# Seattle Design Commission

# MINUTES OF THE MEETING February 16th 2006

Projects Reviewed

16 Feb 2006 Project: Seattle Center Garage

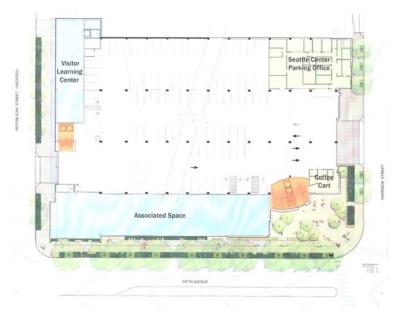
- recommends revisiting the concept design scheme and reconsider housing the visitors' center under a single roof form
- agrees the geometry of the green roof makes it more viable than before
- suggests taking advantage of possible roof access to the north of the visitors' center and above the southeast entry oval so that the public can visually experience the green roof
- suggests that if art is used for wayfinding it be kept distinct and uncluttered by graphics
- recommend pedestrian safety be carefully considered at the Harrison Street entry which is an extremely wide opening for vehicles

- Is the entry structure and circulation core solid or screened?
  - o It is fairly transparent
- Can people get on the roof?
  - o There is a possibility of a terrace, but it is not intended to be a park
- Is the roof design part of the LEED process?
  - o The entire campus seeks LEED rating
  - o The roof will help Lake Union
  - Water on campus may be reused
- The public could learn about the green roof at the Visitor Center
- What are the materials used for the garage?
  - o Possibly bronze metal and limestone veneer

- Is there access to the core from all levels?
  - o Yes
- What about pedestrian safety along Harrison?
  - o It is being considered
- Path to garage should be clearer so pedestrians do not go into the garage office
- The vehicular access apron is too wide
- The Visitor Center does not visually help the garage. The previous version, when one building was considered, was preferable
